TRANSMITTAL

Project Description: Replacement Senior Citizen Center Construction

CHANGE ORDER NO. 46

**PR-94 Complete the Modifications to the Bioinfiltration Swale Storm Riser's and Soil Elevations per Proposal Request No. 80**

LFUGG Senior Center  
 Revisions to grades at Biofiltration Swales  
 5-9-16  
 Scale: 1"=20'-0"

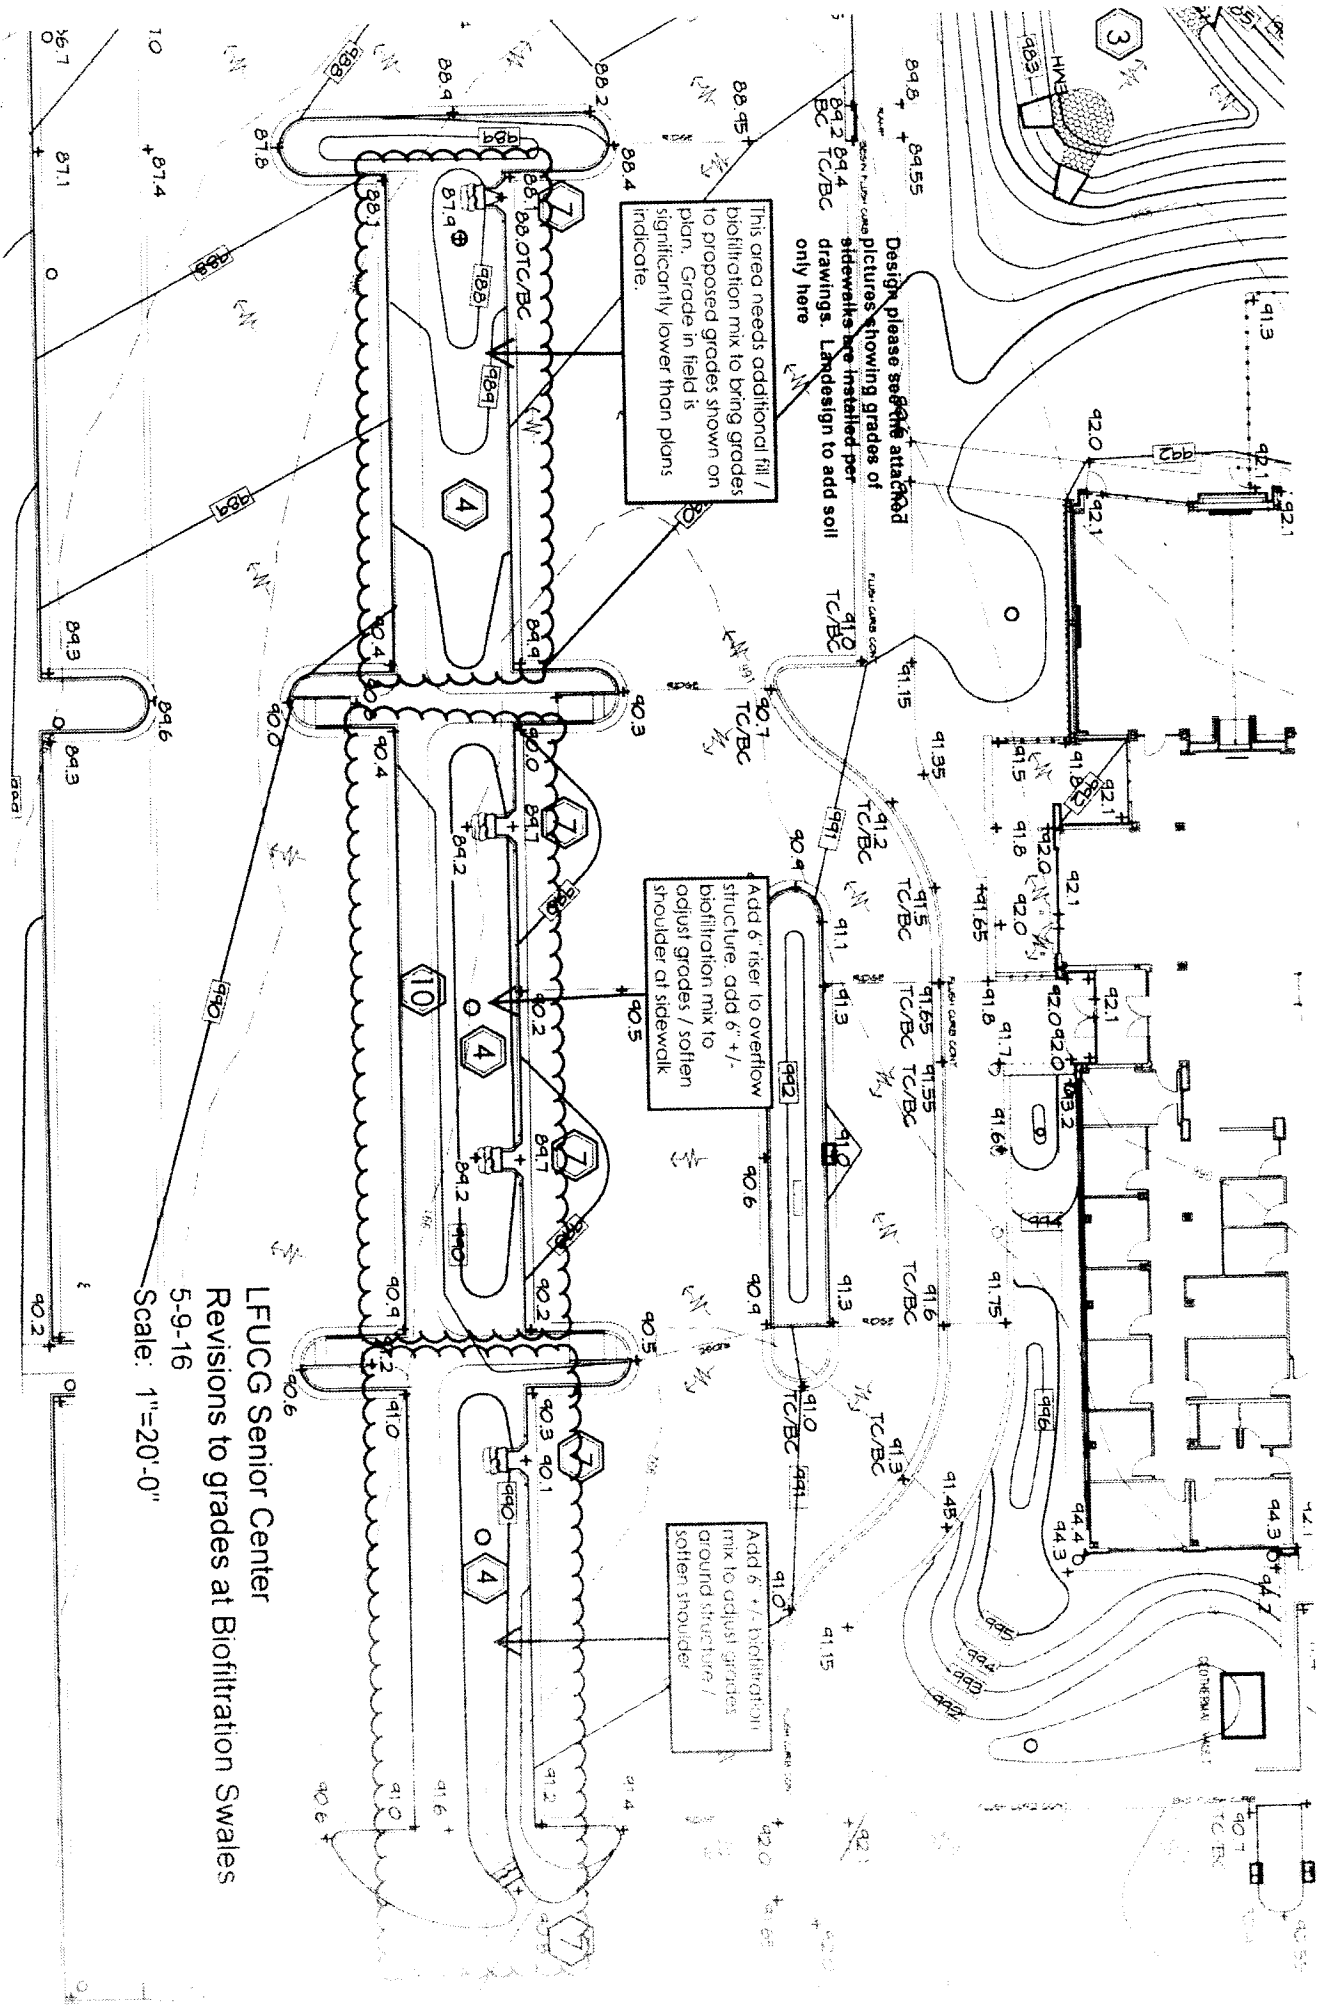
Please provide pricing to make the following adjustments to the center bioswale:

- Raise one yard inlet in middle bay of center bioswale by adding a 6" riser
- Add no more than 6" of biofiltration mix to middle bay of center bioswale to increase all grades by no more than 6", softening to equal grade at sidewalk
- Add no more than 6" of biofiltration mix to east bay of center bioswale to increase all grades by no more than 6", softening to

equal grade at sidewalk

Refer to the attached sketch for reference. The items to be included in the proposal are noted in blue. The items noted in red have been installed at variance with the contract documents, and shall be adjusted to match the contract documents at no additional cost to the owner.

1. Necessity for change: Additional biofiltration mix is needed to adjust grades at the parking lot bioswales. One 6 inch riser is being added to the overflow structure to match the new grade.
